Sealing Air

PrimeServ Customer Information

No. 354 / October 2015

MAN Diesel & Turbo Turbochargers
NR12/S.

Figure sealing air design

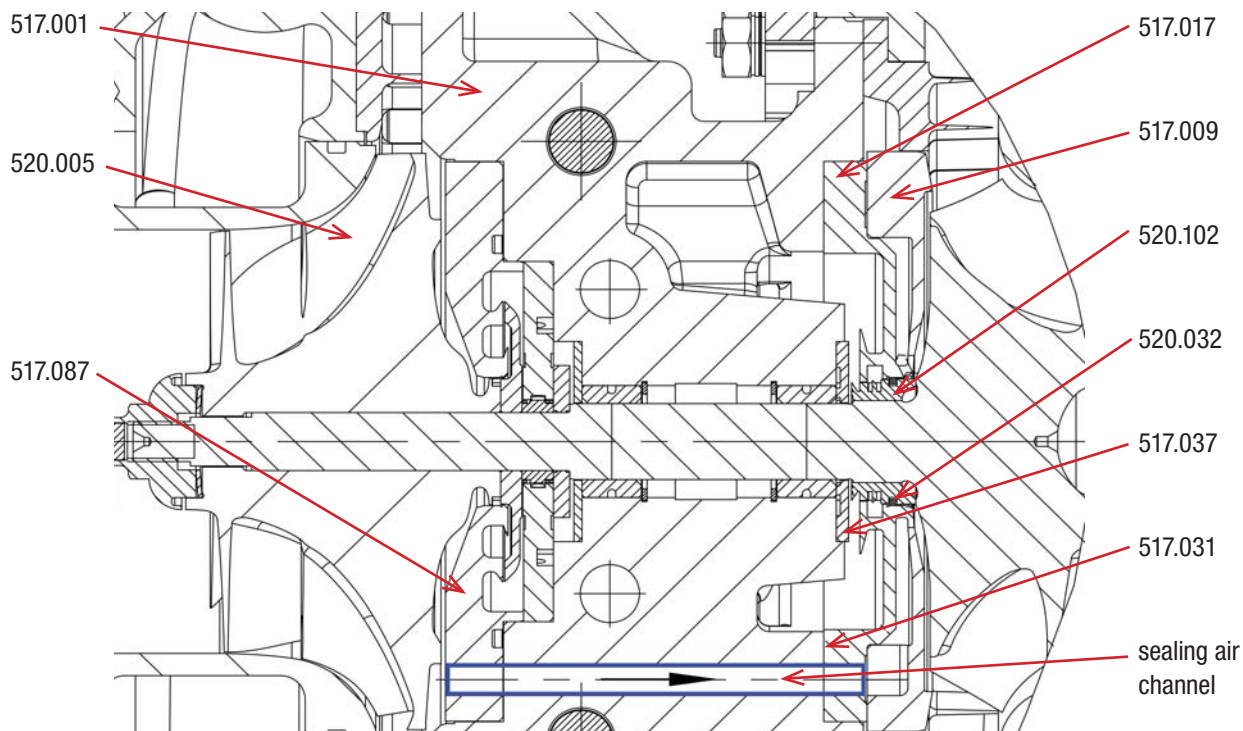
In some cases NR12/S. turbochargers showed advanced wear on the turbine side sealing system. Especially on HFO-operated engines with e.g. insufficient cleaning of the turbocharger, exhaust gas deposits may enter the piston ring sealing area of the turbine rotor resulting in an excessive wear on the piston ring and the locating ring.

In order to avoid exhaust gas deposits on the piston ring (520.032) the following measure is applied:

Internal sealing air is led from the compressor wheel section (rear side of the compressor wheel 520.005) to the location of the turbine side piston ring area. The overpressure behind the turbine wheel prevents the entering of exhaust gas. Heavy contamination by exhaust gas deposits is no longer possible.

To ensure the proper function of the sealing air, the turbine side sealing cover (517.017) is new designed. The new sealing cover is thicker compared to the old one which means the existing gasket (517.031) is replaced by using a special liquid sealing (517.031). Never use the old design sealing cover in upgraded turbochargers!

NR12/S. turbochargers in operation can be upgraded by remachining of the bearing casing (517.001) in one of our workshops and exchanging the following components:

- 517.009 Cover disk
- 517.017 Sealing cover, turbine side
- 517.031 Liquid sealing
- 517.037 Cover
- 517.087 Sealing cover, compressor side
- 520.032 Piston ring
